# UNITED STATES PATENT AND TRADEMARK OFFICE

APPLICATION NO.	FILING DATE	FIRST NAMED INVENTOR	ATTORNEY DOCKET NO.	CONFIRMATION NO.
10/662,150	09/12/2003	Eric S. Toth	04057.008	8722

**Office Action Summary**

## **DETAILED ACTION**

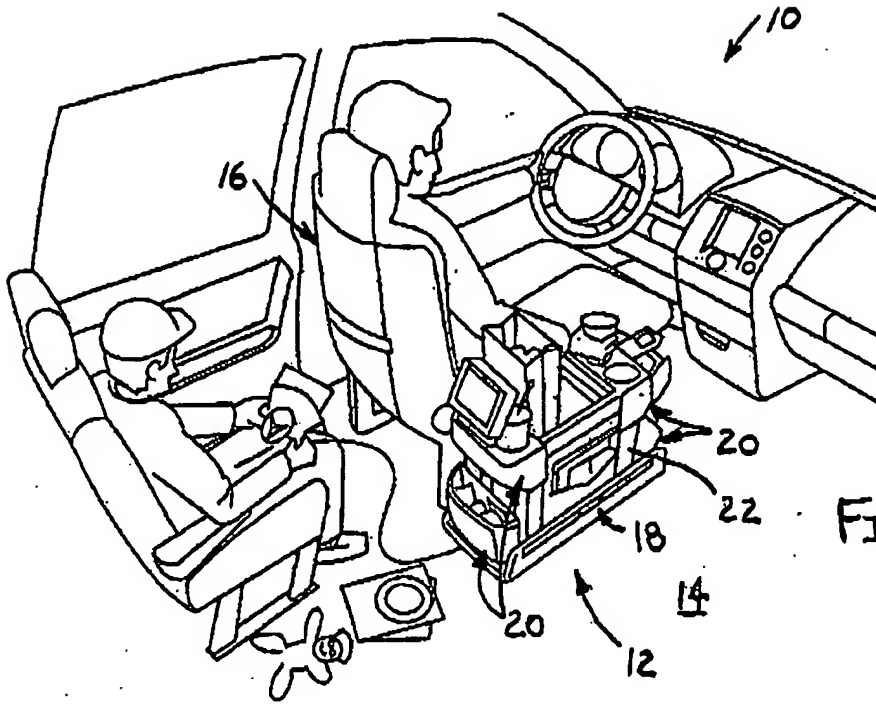
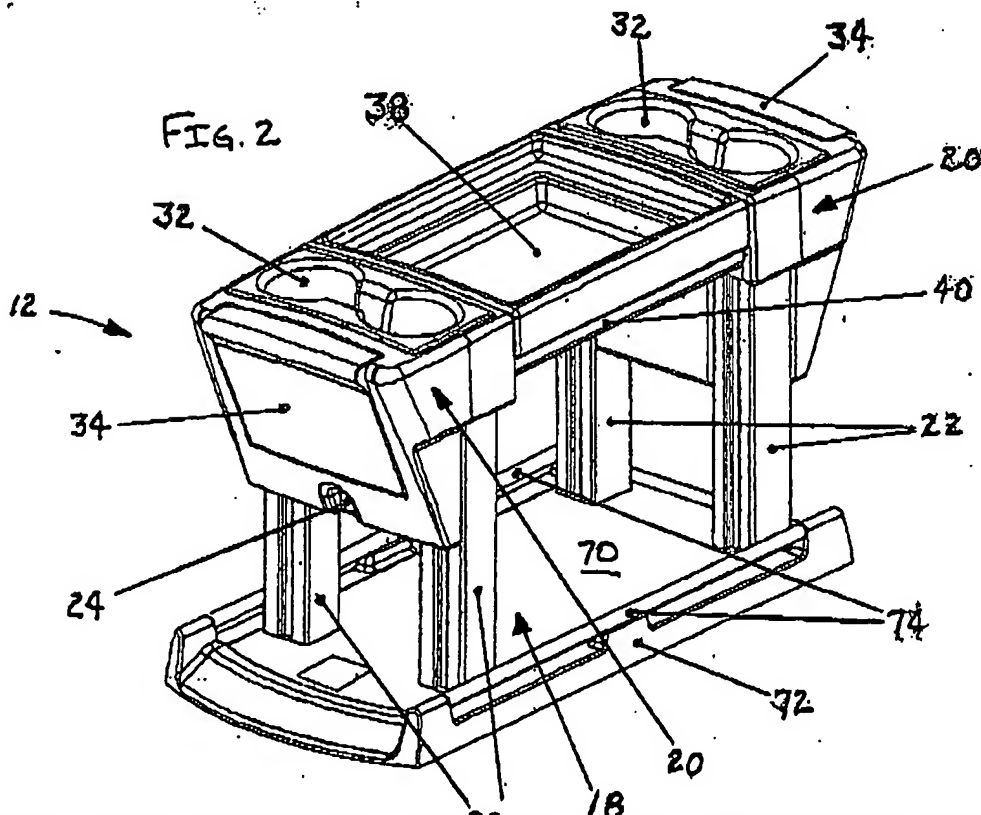
DHP  
7/15/2005

Approved  
DIP  
7/15/05

FIG. 3

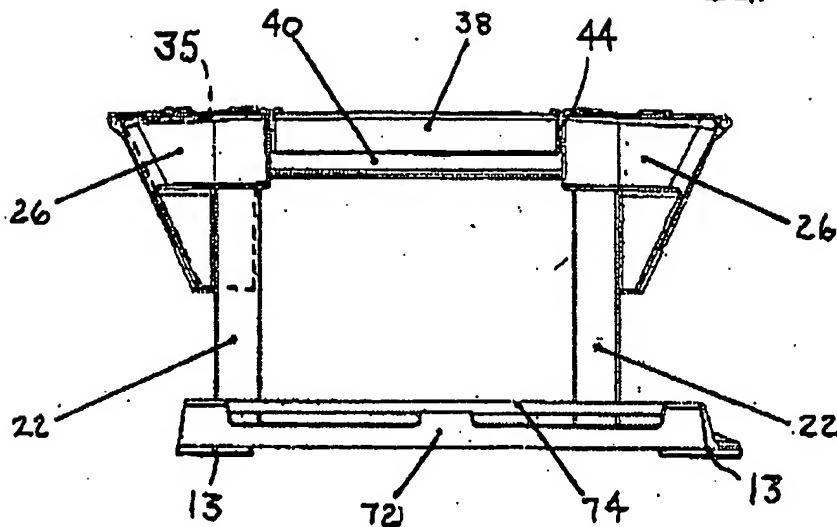
approved  
JLP  
7/15/05
